ADDENDUM

ADDENDUM NO.: 03
PROJECT NAME: Minnie Mars Jamieson Elementary School Annex and Renovation
PROJECT NO.: 05760
CONTRACT NO.: C1567
DATE OF ISSUE: May 20, 2015

NOTICE OF CHANGES, MODIFICATIONS, OR CLARIFICATIONS TO CONTRACT DOCUMENTS

Sheet: **A6.0**

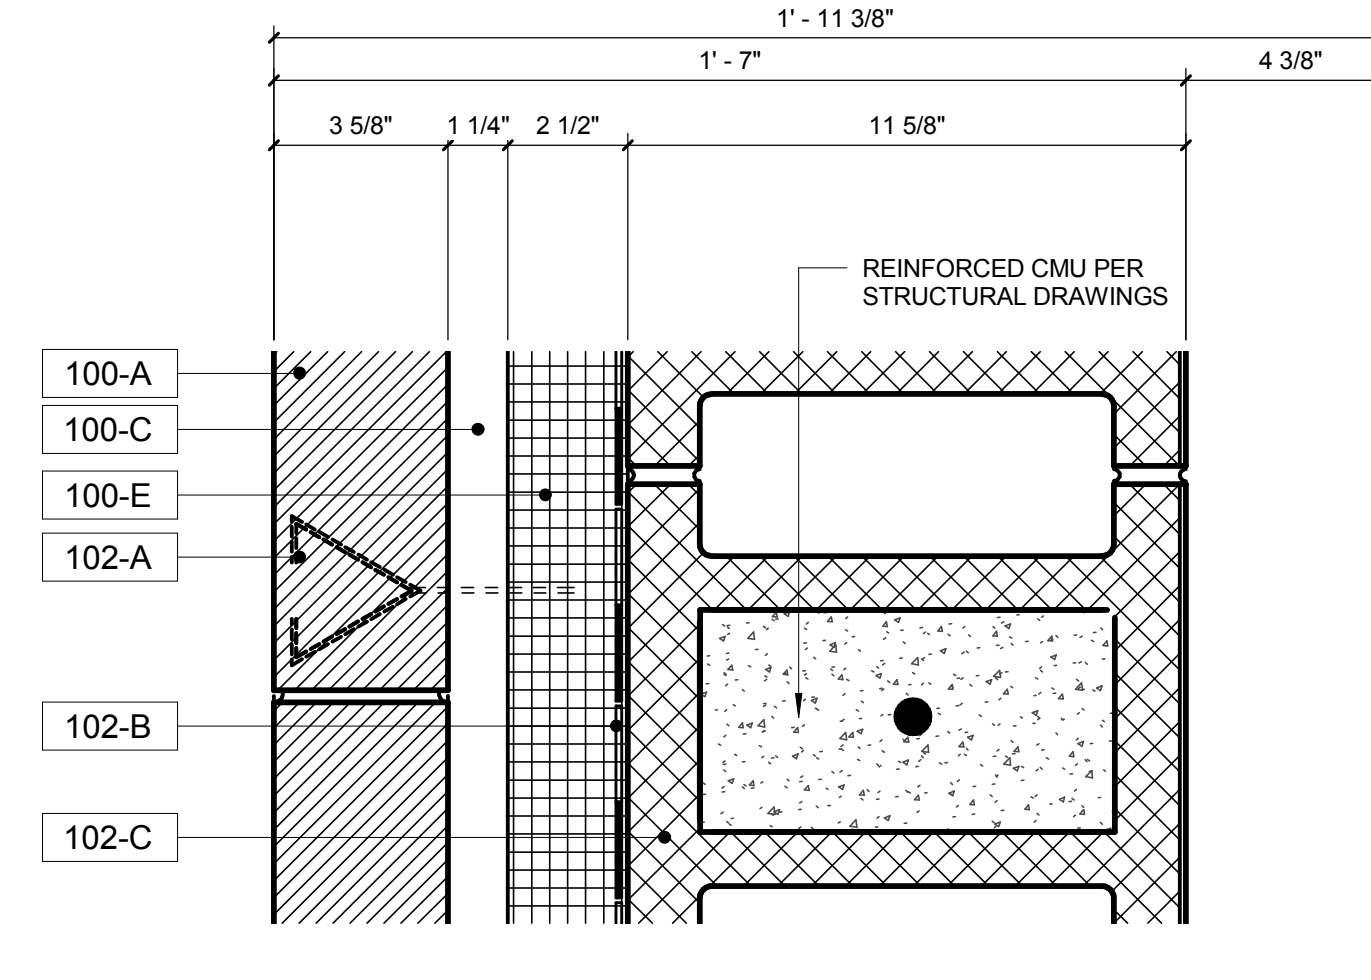
- Change 1. Drawing Sheet A6.0 ENLARGED PLAN KEYNOTES AND TYPICAL CONSTRUCTION:**
ADD Keynotes
ADD Revision 3 mark and dated 05/19/2015, attached.
- Change 2. Drawing Sheet S1.2A SECOND FLOOR FRAMING PLAN:**
REVISE Keynote 1 to define (20 GA) thickness for composite steel deck.
REVISE Keynote 3 to define (20 GA) thickness for composite steel deck.
ADD Revision 3 mark and dated 05/19/2015
***NARRATIVE ONLY, DRAWING NOT RE-ISSUED**
- Change 3. Drawing Sheet S1.3A THIRD FLOOR FRAMING PLAN:**
REVISE Keynote 1 to define (20 GA) thickness for composite steel deck.
REVISE Keynote 2 to define (20 GA) thickness for composite steel deck.
***NARRATIVE ONLY, DRAWING NOT RE-ISSUED**

- RFI-1** On Sheet A6.1 – details 1-3, 4-5 and 8 show a keynote 107-X. There is no 107-X keynote on sheet A6.0. Please advise.

RESPONSE: Information for Keynote 107-V, 107-W, and 107-X have been added to drawing A6.0.

107-U	MECHANICAL DIFFUSERS. REFER TO MECHANICAL DRAWINGS.
107-V	HIGH STRENGTH CORNER BEAD TO BE USED BY SEFT FORME OR APPROVAL EQUAL. PROVIDE HIGH-STRENGTH CORNERS ON ALL EXPOSED OUTSIDE WALL CORNERS.
107-W	ELECTRICAL FIXTURES. REFER TO ELECTRICAL DRAWINGS. FIXTURES + INSTALLATION SHOWN DIAGRAMMATICALLY ONLY.
107-X	CLOSE THE VOID BETWEEN PARTITION AND UNDERSIDE OF DECK WITH MINERAL WOOL (SAFING INSULATION) AND FIRE BARRIER SEALANT WITH AN 1-HOUR RATING U.L. APPROVED SYSTEM.
